Questions and comments HEAL Utah is submitting for a response at the public hearing scheduled for Wednesday September 8, 2021 regarding EnergySolutions: Amendment 3 of 11e.(2) License UT2300478. Submitted to the Utah Division of Waste Management and Radiation Control August 27, 2021.

Federal Cell Facility Amendment Request

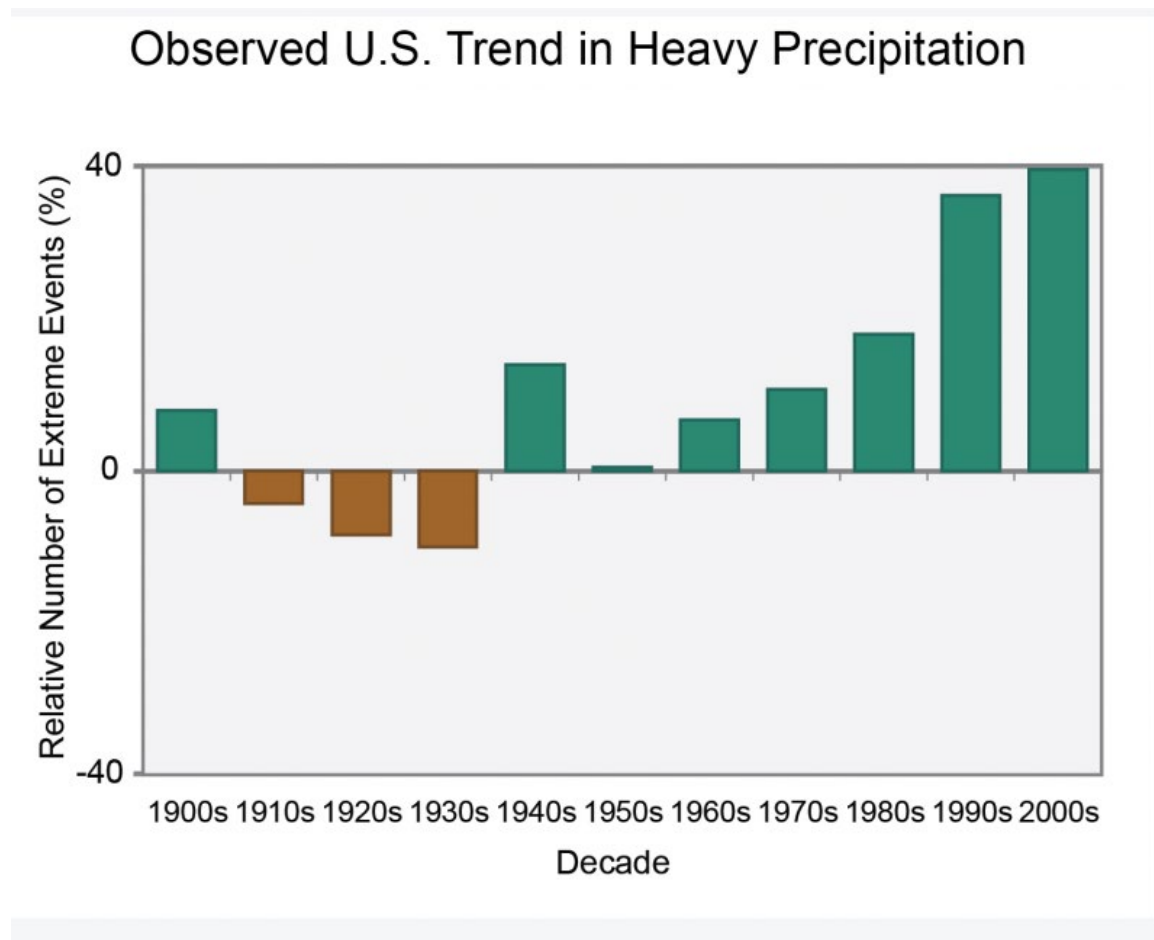
Questions 8 and 9. Given the dramatic increase in heavy precipitation events across the U.S. due to climate change (see chart below), even during the 18 years since Atlas 14 was published, what is DWMRC's confidence in the accuracy of the Probable Maximum Precipitation scenarios? Will DWMRC require EnergySolutions to revise its Storm Events assumptions and design as NOAA's modeling is updated? <https://www.c2es.org/content/extreme-precipitation-and-climate-change/>
